Final
Environmental Impact Statement
for
Remedial Action Standards
for
Inactive Uranium Processing Sites
(40 CFR 192)

Volume II

APPENDIX D: RESPONSE TO COMMENTS

APPENDIX E: COMMENT LETTERS AND TESTIMONY PRESENTED AT PUBLIC HEARINGS

FIGURE 1 RADON - 222 FLUX AT SURFACE FROM A 15-cm THICKNESS OF TAILINGS VERSUS DEPTH BELOW SURFACE

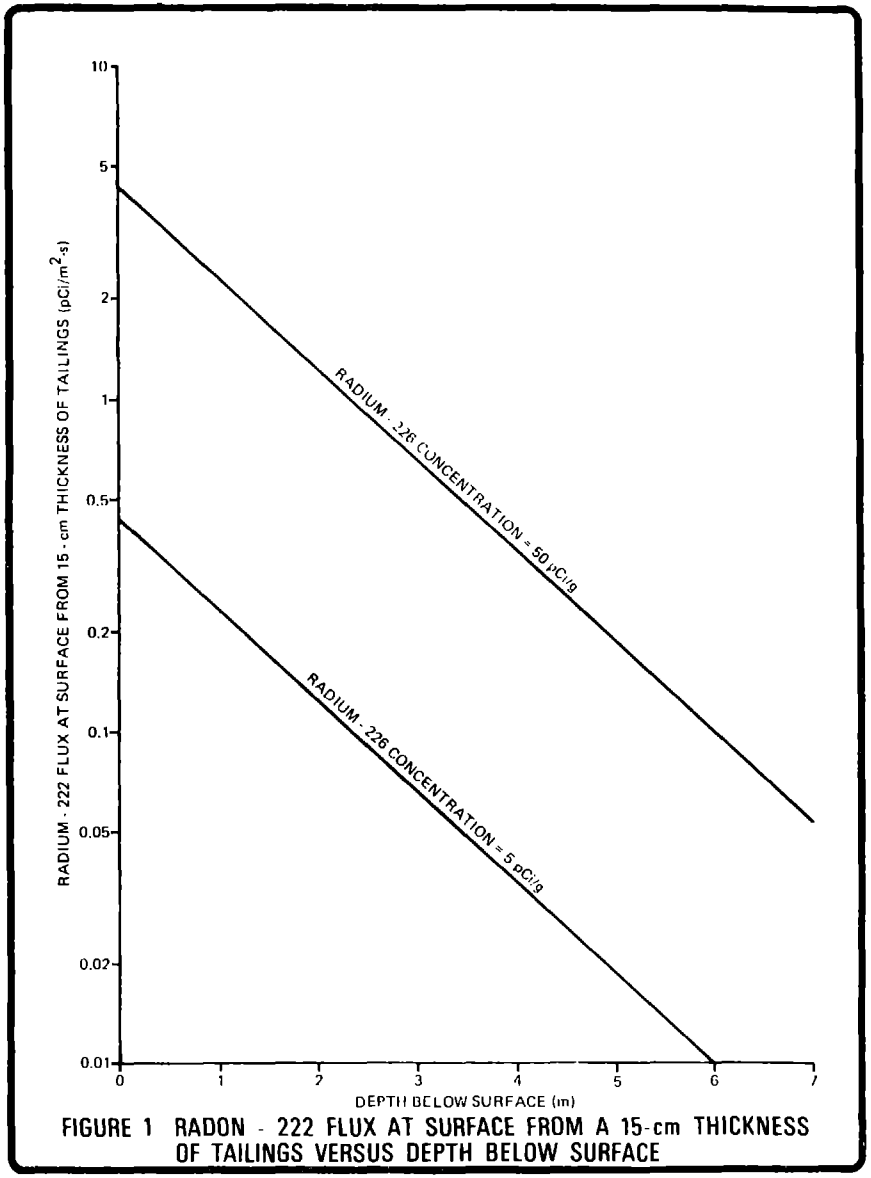
From Figure 1 it can be seen that a 15-cm thickness of tailings or contaminated material which is covered by slightly more than 1 m of dry soil and whose radium-226 concentration is about 50 pCi/g will produce a flux at the surface of about 2 pCi/m^2-s. Suppose then that contamination extends to 1 m below the intended final grade and the average radium-226 concentration attributable to residual radioactive material at 1 m below the final grade is 5 pCi/g, as required by the proposed cleanup standards. The radon-222 flux at the final grade which would result from a 15-cm thickness of such contaminated soil at the 1-m depth would be about 0.2 pCi/m^2-s. Thus the proposed cleanup standard under likely conditions may be much more restrictive than the proposed disposal standard, in terms of release of radon-222 to the atmosphere. That is to say, whereas the proposed disposal standard allows radon-222 release to the atmosphere which is considered acceptably low in terms of risk to the public, the proposed cleanup standard for contaminated open lands under likely conditions would potentially require a radon-222 release rate 10 times smaller. Finally, the question is raised, "If the risk to the public is acceptably low for disposal of tailings and contaminated material, why should the contaminated material be cleaned up to standards which may be 10 times more restrictive?"

FIGURE 2 COST - BENEFIT RATIO VERSUS DEPTH BELOW FINAL GRADE

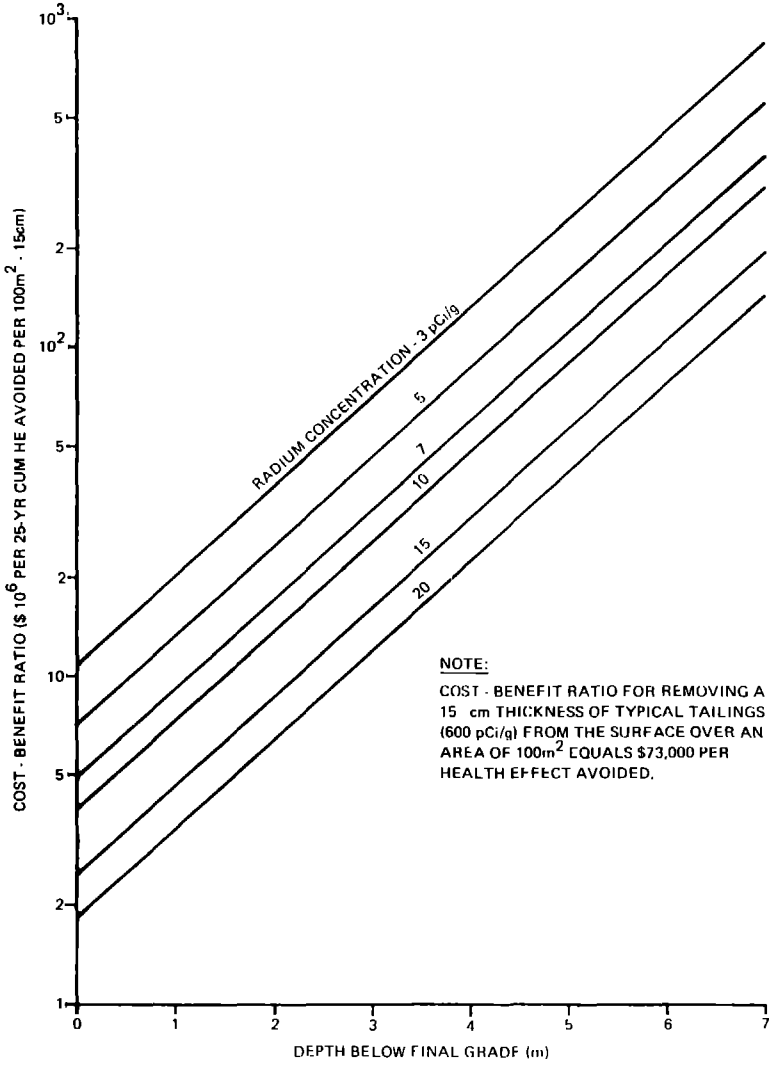
benefits of removing 15 cm of contaminated soil (or tailings) under various conditions, as well as the resulting benefits, were estimated for a 100-m^2 area at the Vitro site in Salt Lake City. The cost-benefit ratio is presented in Figure 2 as a function of depth below final grade, with radium concentration as a parameter.

The note on Figure 2 shows that removal of 15 cm of typical tailings (600 pCi/g of radium-226) from 100 m^2 of the present surface has a cost-benefit ratio of about $73,000 per health effect (case of lung cancer) avoided. This suggests that removal of the top 15 cm of tailings is a very cost-effective undertaking, when measured in terms of health effects avoided. By contrast however, the cost-benefit ratio of removing 15 cm of contaminated soil with a radium-226 concentration of 10 pCi/g at a depth of 1 m below final grade is a startling $9,000,000 per health effect avoided, or more than 100 times less cost-effective.

FIGURE 3 POSSIBLE STANDARD FOR CLEANUP OF RADIUM - 226 IN OPEN LANDS

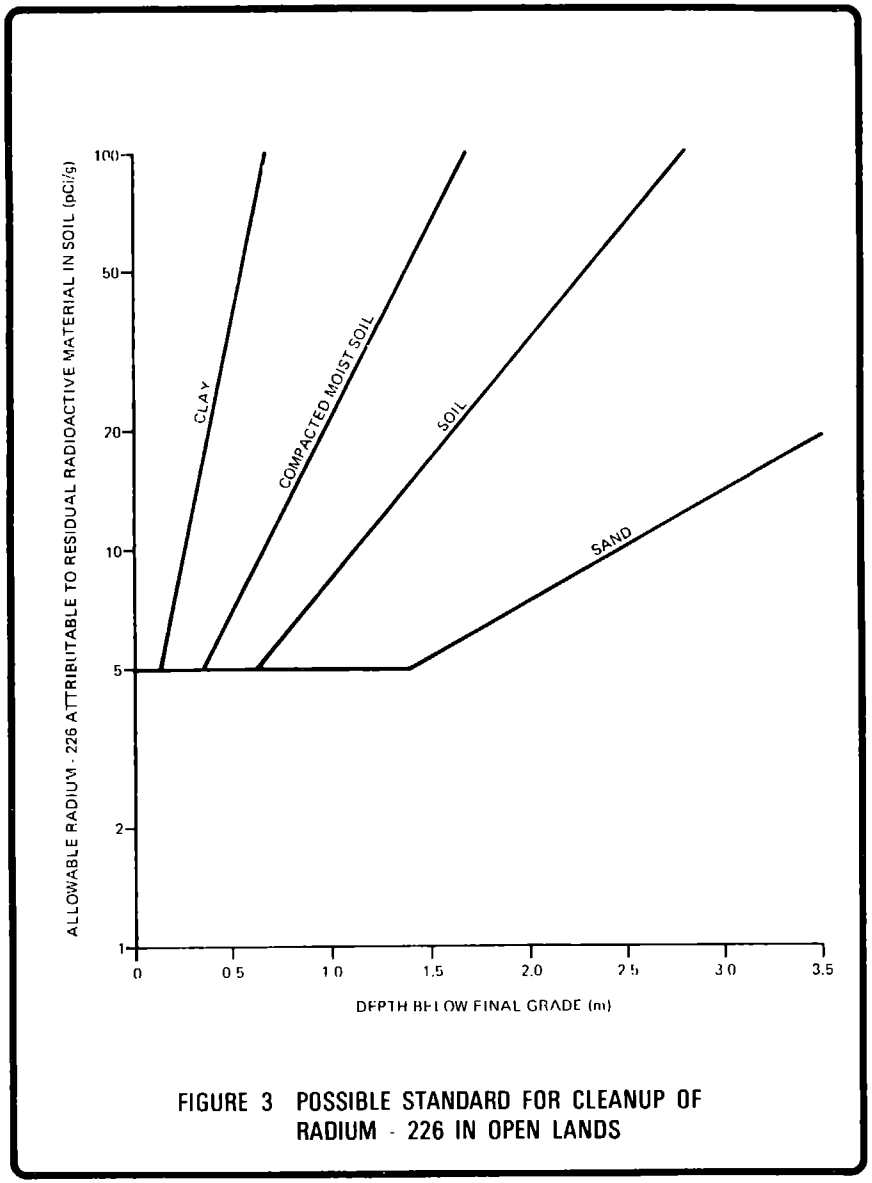
Because of the potential contradiction between the proposed standard for cleanup of contaminated open lands and the proposed standard for tailings disposal, and because of the need for common sense, allowing for the exercise of good judgement during decontamination, the standards for cleanup of contaminated open lands should be relaxed. The concept depicted in Figure 2 forms a rational basis for a quantitative tool to be used in such exercise of good judgement.
